CERTIFICATE OF APPROPRIATENESS

Property: 8339 Glencrest St., Lot 10, Block 12, Glenbrook Valley Section 4, Houston, Texas 77061

Proposal: Project Type Alteration – rear porch and reroof

Recommendation: Approval with conditions: ridge height of proposed roof be lower than existing.

PROPOSED ROOF PLAN

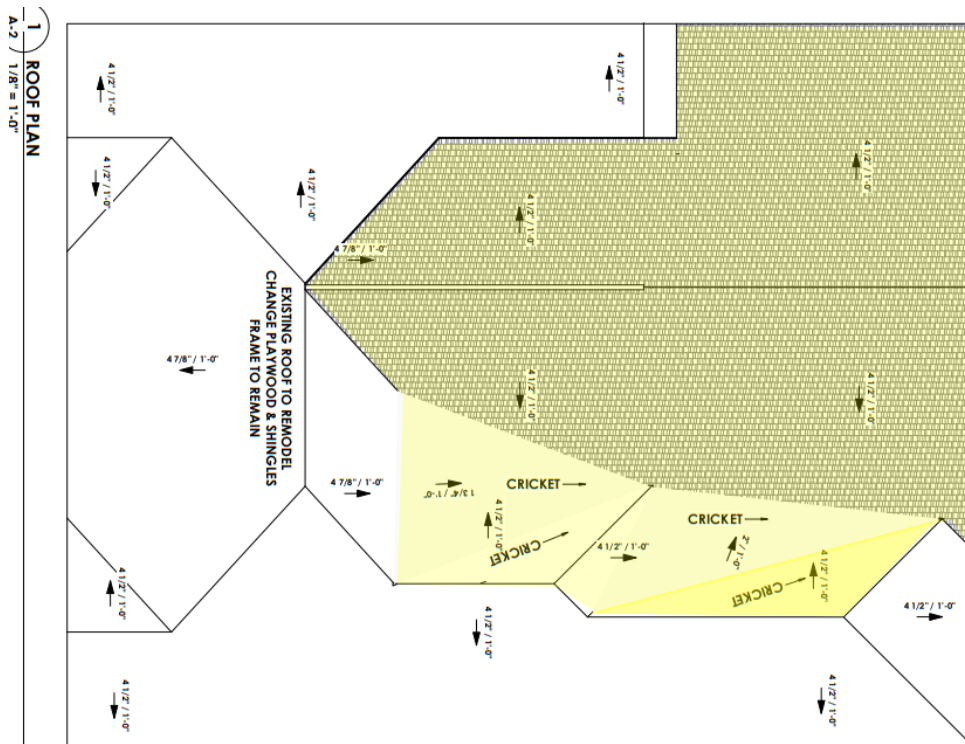
<i>Proposed roof form is not typical of contributing context (rear gable porch extended from existing ridge) should start slightly lower than existing height to differentiate from historic roof. If ridge height is dropped, historic form would be more prominent.</i> |

<i>Proposed roof form and massing is not typical of contributing context (rear gable extended from existing ridge) should start slightly lower than existing height to differentiate from historic roof. If ridge height is dropped, historic form would be more prominent</i> |
